SB-10043911-9293

SI B34 01 12
Brakes

Service Action: Replace Integrated Chassis Control Module (ICM)

6 Series (F13)

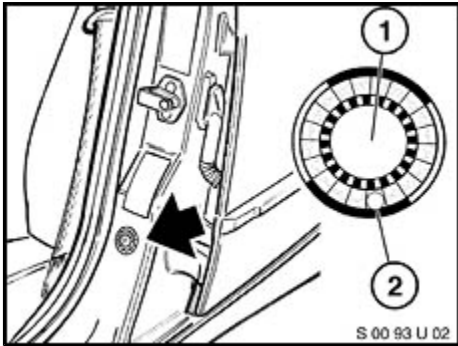
This Service Action has been assigned code number **607**. After the vehicle has been checked and/or corrected, obtain a label (SD92-403) and:

- A. Emboss your BMW center warranty number in the middle of the label (1);
- B. Punch out code number **607** (2), printed on the label; and
- C. Affix the label to the **B**-pillar as shown.
